A RESOLUTION OF THE CITY COUNCIL OF THE CITY OF MILPITAS DENYING MAJOR TENTATIVE MAP NO. MT13-0007, SITE DEVELOPMENT PERMIT NO. SD13-0013 AND CONDITIONAL USE PERMIT NO. UP13-0013 FOR THE DEVELOPMENT OF 362 APARTMENT UNITS, APPROXIMATELY 55,431 SQUARE FEET OF COMMERCIAL-RETAIL SPACE IN A MIXED USE BUILDING AND APPROXIMATELY 241 CONDOMINIUM/TOWNHOUSE UNITS LOCATED IN THE MCCANDLESS/CENTRE POINTE AND MONTAGUE CORRIDOR SUB-DISTRICTS OF THE TRANSIT AREA SPECIFIC PLAN ON APPROXIMATELY 15.68 ACRES

WHEREAS, on July 17, 2013 an application was submitted by Integral Communities McCandless LLC (“Applicant”) at 3 San Joaquin Plaza, Suite 100, Newport Beach, CA 92660, to request for a Major Tentative Map, Site Development Permit, and Conditional Use Permit for the development of “three neighborhoods” totaling approximately 603 residential units and 55,421 square feet of commercial-retail space on approximately 15.68 acres located at 1310 – 1360 McCandless Dr. (APN: 086-33-101), 1463 Centre Pointe Dr. (APN: 086-33-086), 1501, 1507, 1515 Centre Pointe Dr. (APN: 086-33-087), 1536 – 1567 Centre Pointe Dr. (APN: 086-33-088), and 1577 – 1601 Centre Pointe Dr. (APN: 086-33-089) (“Project”).

Figure 7
TASP Street Network for Centre Pointe

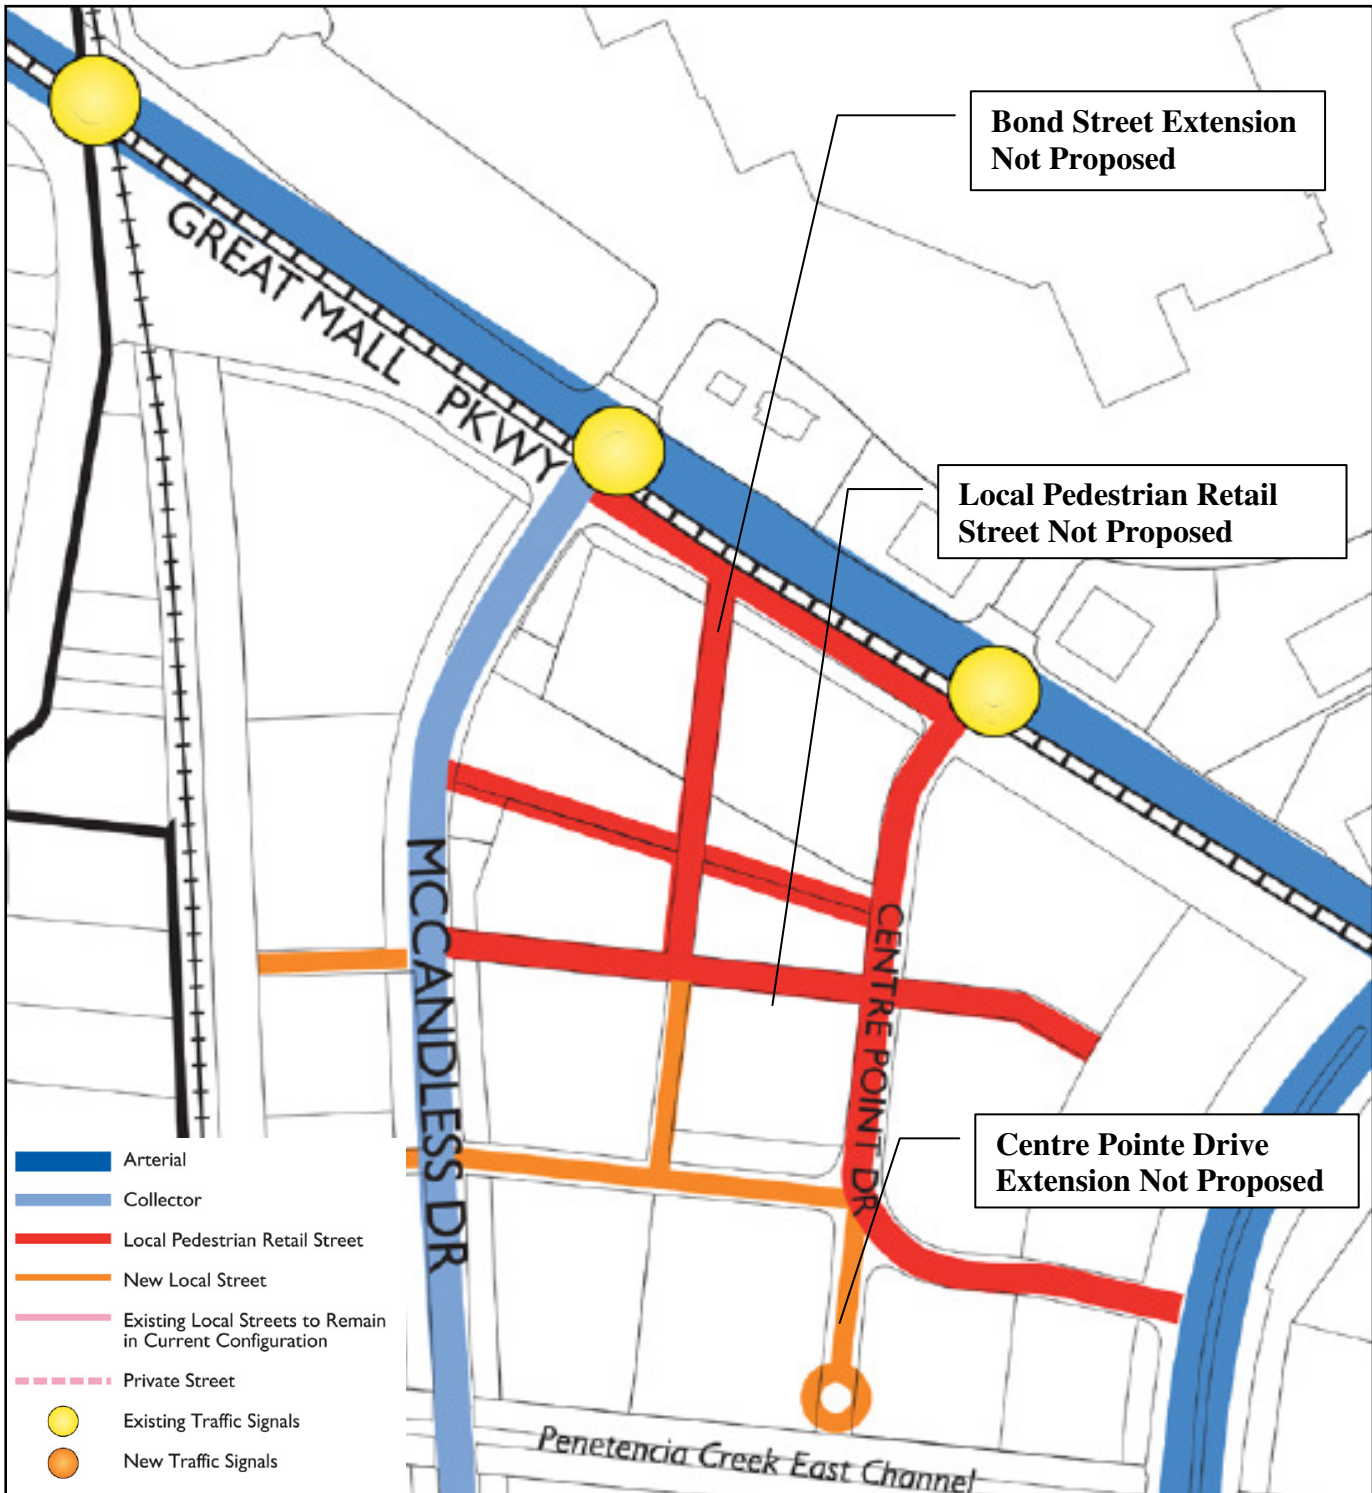
The proposed Project's circulation system is inconsistent with the TASP. Figure 7 illustrates the street network prescribed by the TASP. The inconsistencies with this network are summarized by street on the subsequent page.

The TASP illustrates Bond Street providing a connection to Great Mall Parkway. The proposed Project does not extend Bond Street to Great Mall Parkway and instead, Bond Street ends at a parking garage for Neighborhood A, inconsistent with the TASP. TASP Policy 4.60 requires that block lengths do not exceed 450 feet, and encourages shorter block lengths of 300 to 400 feet. Bond Street measures approximately 610 feet from Newbury Street to Market Street. Therefore, Bond Street is inconsistent with the TASP street layout and block lengths.

The street layout and alignment for the proposed Centre Pointe Drive does not extend southward as planned for in the TASP. Additional analysis and studies are needed to determine the ultimate alignment and layout for this roadway and may be inconsistent with the TASP. Further, Centre Pointe Drive measures approximately 560 feet from Newbury Street to Market Street. This is inconsistent with TASP Policy 4.60 which requires block lengths not to exceed 450 feet.

The TASP Street Design and Character Plan illustrates a street bisecting the approximate location of Neighborhood B. The proposed Project does not incorporate this street. The TASP identified street is designed to be used as a pedestrian retail street. This proposed missing street further emphasizes the proposed Project's inconsistency with the TASP and the importance of providing mixed use development along a planned street frontage in Neighborhood B.
